Our Ref: 22-12/001240
CRC Ref: ROL 2023_5271/1
Date: 6 April 2023

RE: RESPONSE TO INFORMATION REQUEST IN RELATION TO AN APPLICATION FOR RECONFIGURING A LOT (1 LOT INTO 6 LOTS PLUS COMMON PROPERTY) ON LAND AT 501 – 505 OLD PORT ROAD, CRAIGLIE

We hereby provide the following information in response to Council's Information Request dated 24 February 2023.

501-505 OLD PORT ROAD, CRAIGLIE (LOT 303 ON C2251)
1 INTO 6 LOT SUBDIVISION
MASTERPLANS
SEWER AND WATER CONCEPT

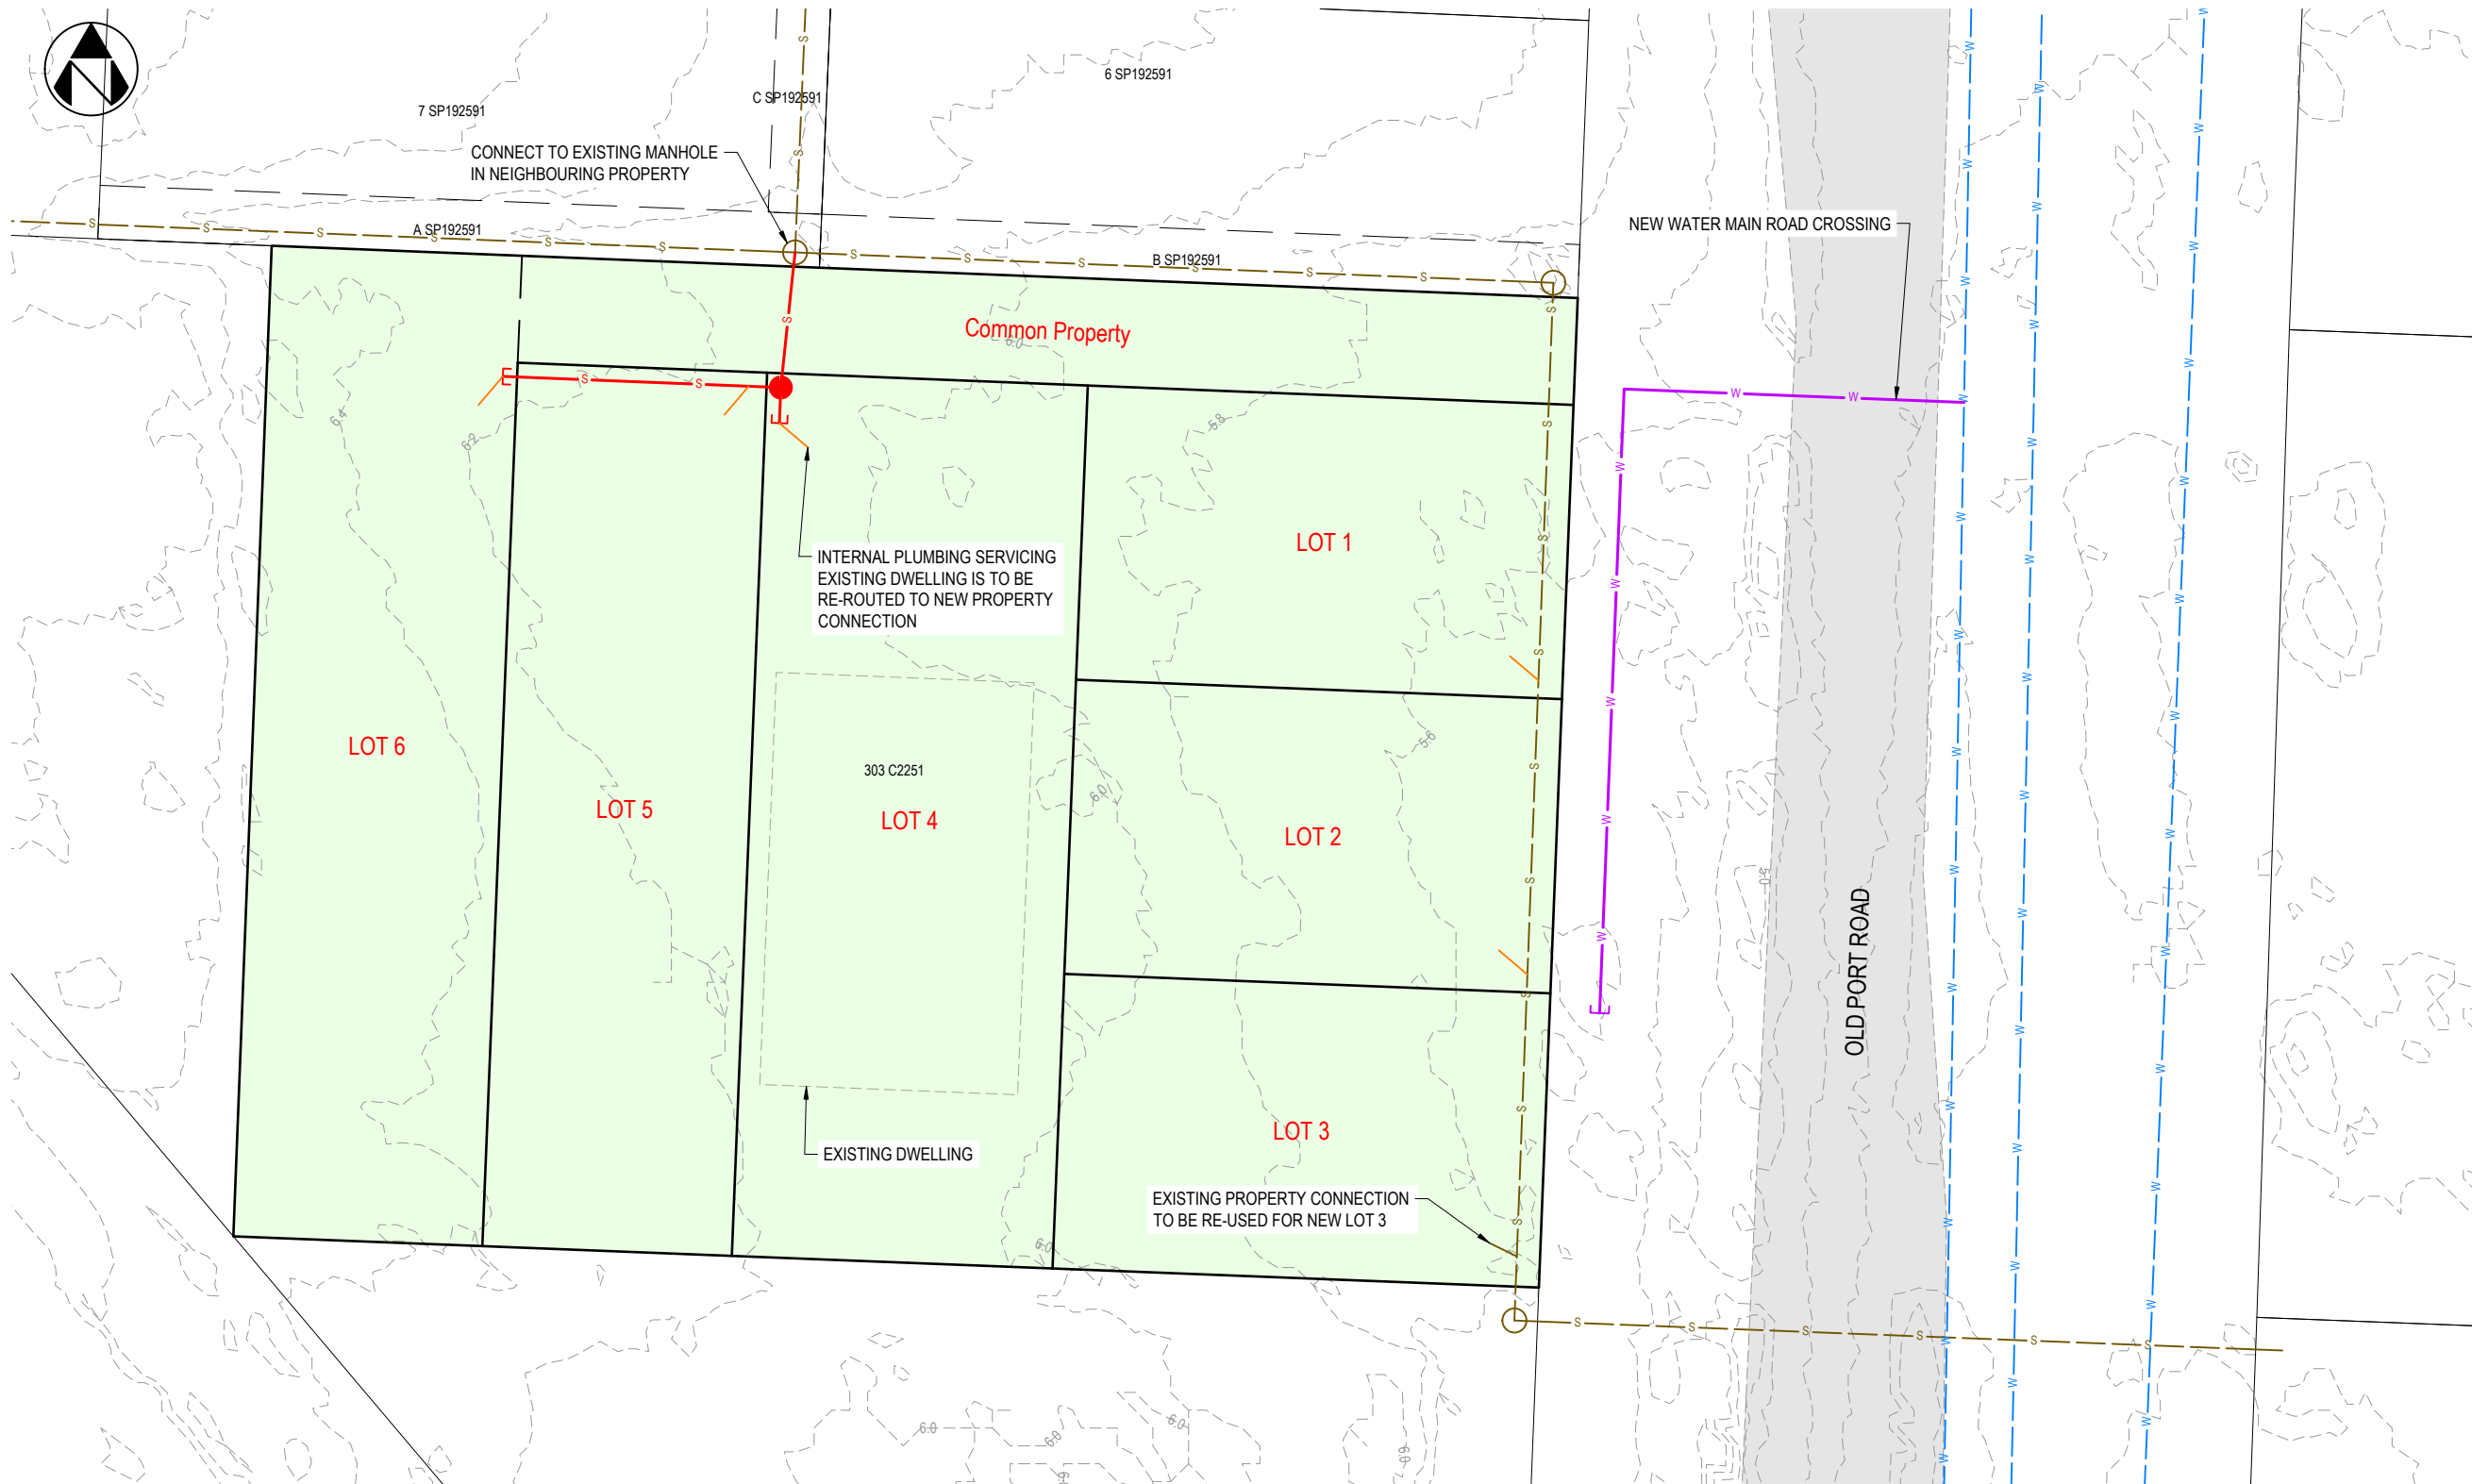
4. Demonstrate how each proposed allotment will be serviced by water and sewer connections and provide a plan detailing any augmentation of sewer, water road crossings and water connections.

Water supply and sewer plans are included as **Annexure 1**.
